ALPINE CITY PLANNING COMMISSION MEETING

A. Major Subdivision Final Plat Review – Montdella – Alan Cottle

ALPINE PLANNING COMMISSION AGENDA

ACTION REQUESTED BY PETITIONER: Recommend Approval of the Final Plat and Plans

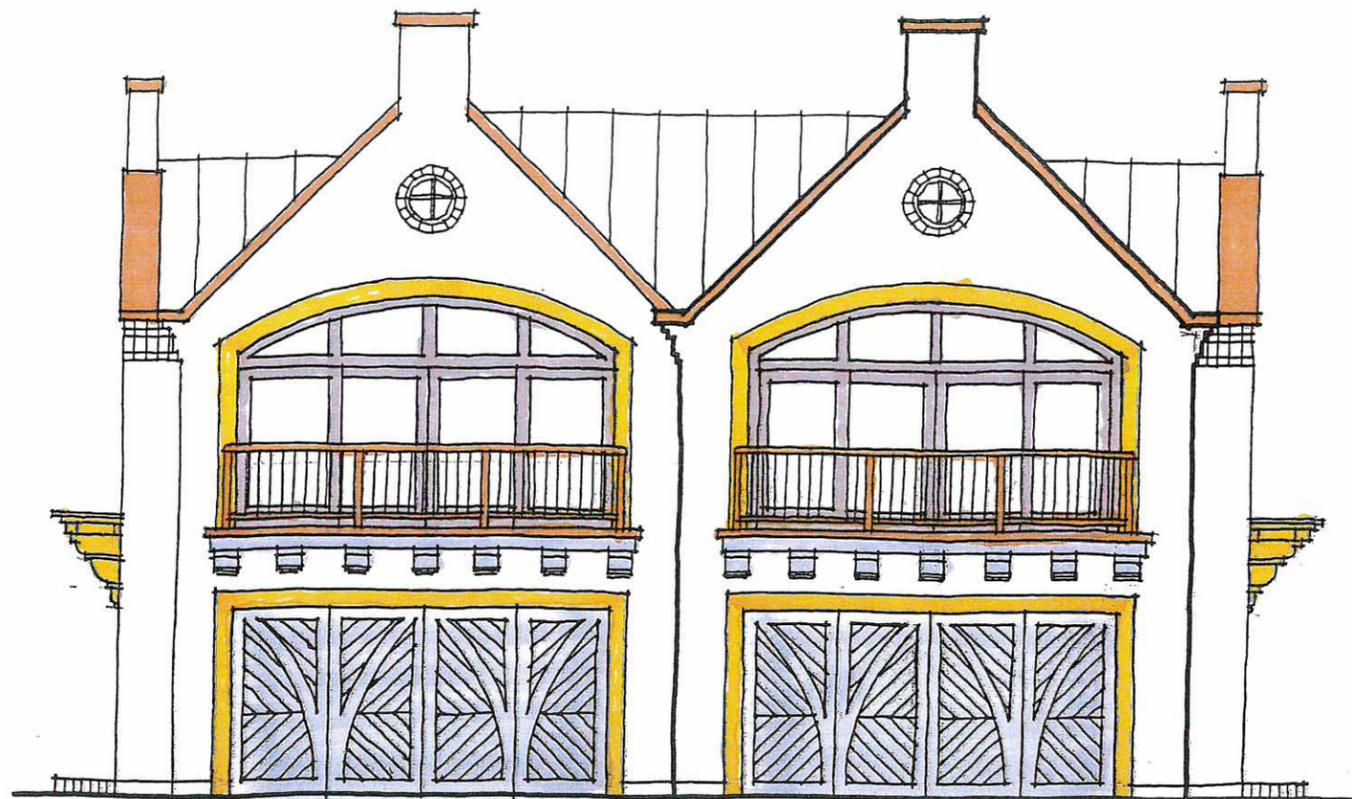
The development proposes 26 culinary ERC's, 2.33 irrigated acres, and 26 sanitary sewer ERU's. The current master plan anticipated 20.4 culinary ERC's, 0.6 irrigated acres, and 20.4 sanitary sewer ERU's. Proposed connections are slightly higher than anticipated for this area.

The proposed culinary water improvements have been modeled in both the current and buildout models. The proposed improvements fit well within the City's culinary water master plan and modeling shows them to be adequate. The following comments and recommendations are noted for the proposed culinary water system.

The proposed pressurized irrigation improvements have been modeled in both the current and buildout models under both wet and dry year supply conditions. The proposed demands are more than the City's pressurized irrigation master plan but modeling shows them to be adequate. The following comments and recommendations are noted for the proposed pressurized irrigation system.

The proposed sanitary sewer improvements have been modeled in both the current and buildout models. The proposed improvements fit well within the City's sanitary sewer master plan and modeling shows them to be adequate. The following comments and recommendations are noted for the proposed sanitary sewer system.

2. Fire flow available in the area surrounding the proposed improvements should be over 3000 gallons per minute at 20 psi for the proposed lines.
